**UNITED STATES AIR FORCE
CAPE NEWENHAM LRRS, ALASKA**

DECISION DOCUMENT FOR UPPER CAMP (SS07)

FINAL

U.S. FISH AND WILDLIFE SERVICE COMMENTS ON MAY 2000 PROPOSED PLAN FOR SS07
CAPE NEWENHAM LRRS, ALASKA

Figure 2. Location of Investigation Sites at Cape Newenham LRRS, Alaska

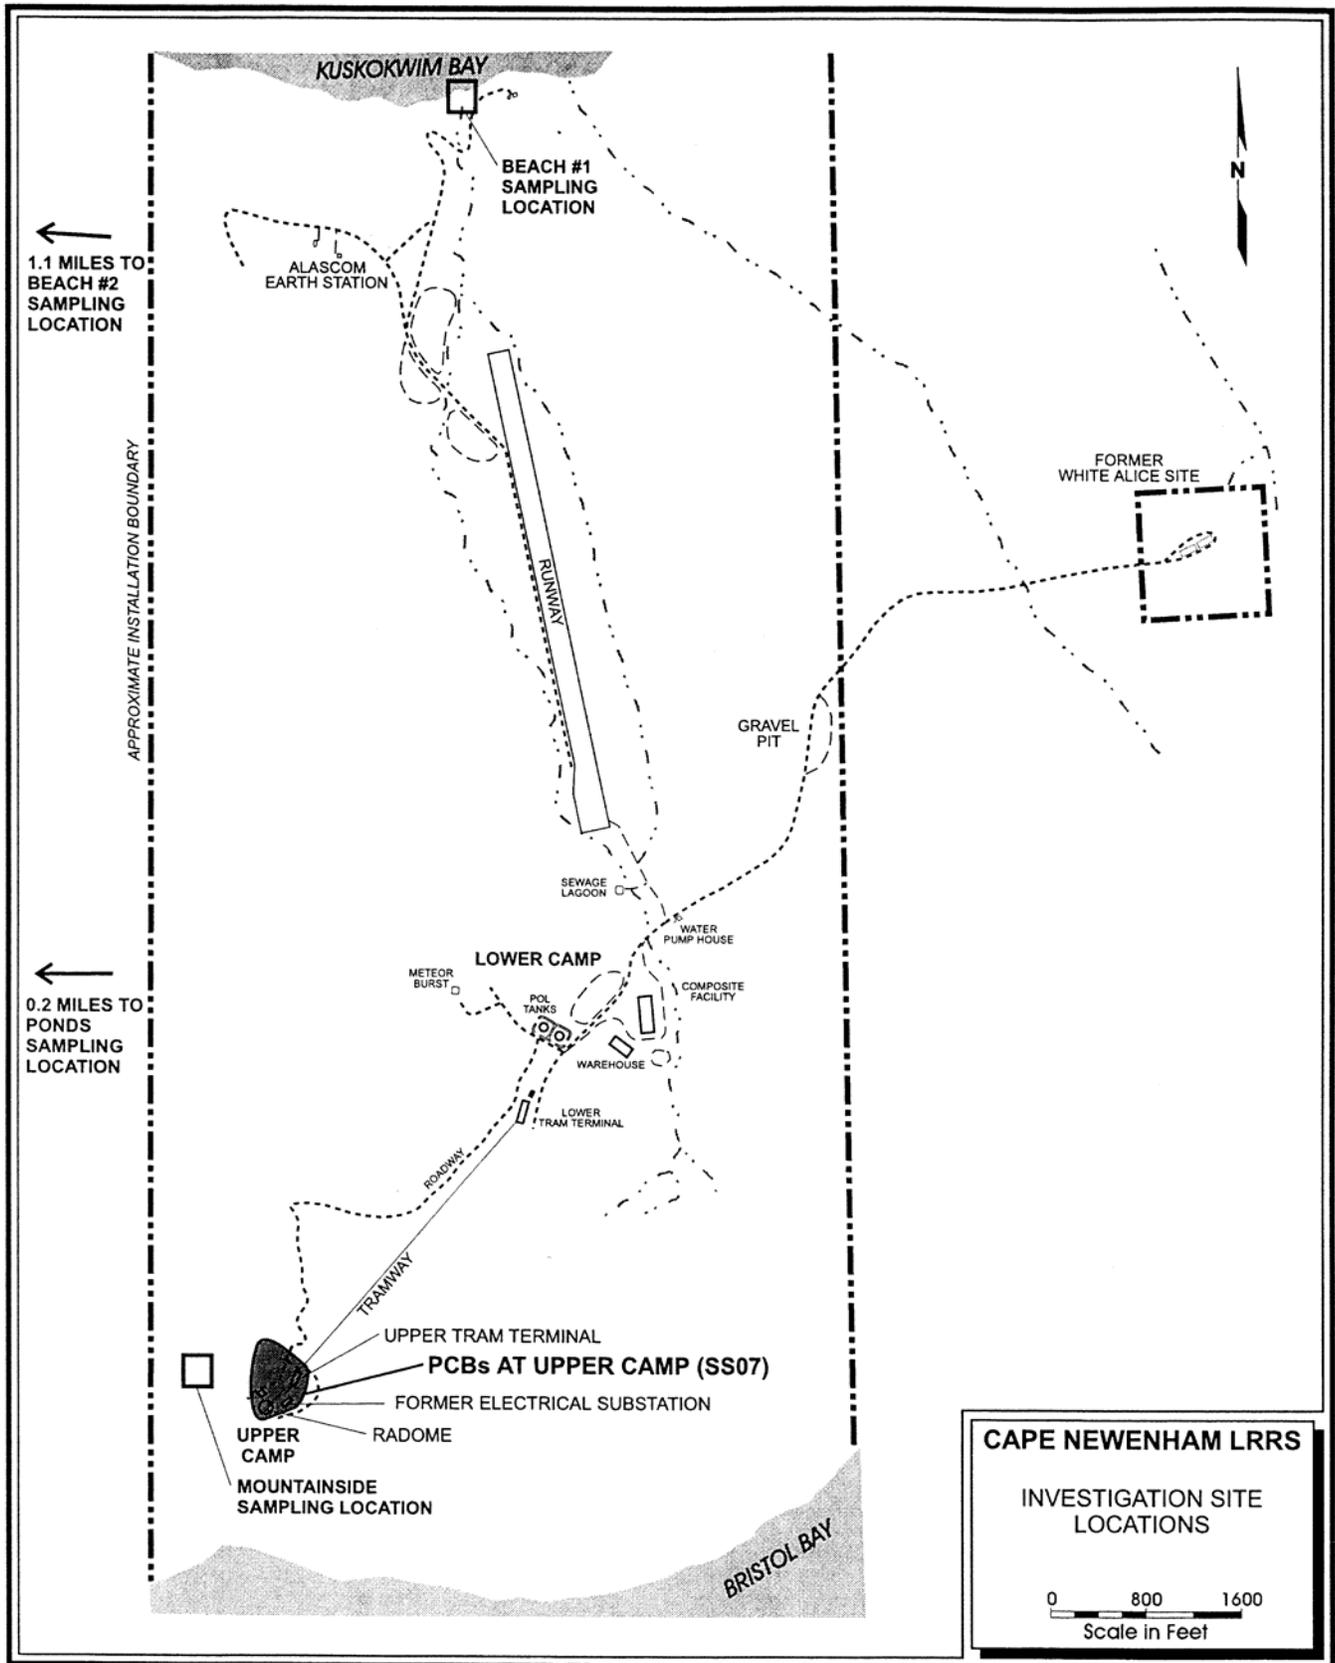
USFWS COMMENTS				RESPONSE
NO	PAGE	SECTION	COMMENT	
4	General	General	The Proposed Plan should identify current and formerly used landfills on Figure 2 (and/or Fig. 4, as appropriate) and describe any hazardous materials contained within these landfills.	The proposed plan is limited to addressing only LF03 and SS07 and was written as a summary document, focusing primarily on cleanup alternatives. Reports pertaining to former landfills are available in the administrative record.
5	2	Paragraph 1	The location of Platinum, Alaska should be identified on Figure 1.	As the proposed plan is a final document, the location of Platinum, Alaska will not be included. However, the location is denoted in the decision documents.
6	2	Paragraph 2	Has there been a remedial investigation at the White Alice site that was deactivated in 1979? If so, what documents are associated with this investigation and where are they located? We wish to review any available reports or similar documents pertaining to this site, particularly if they address disposition of debris and wastes.	The proposed plan is limited to addressing only LF03 and SS07 and is written as a summary document, focusing primarily on cleanup alternatives. Documents pertaining to investigations and remedial actions at the White Alice Site are part of the administrative record and are available for review by the USFWS.
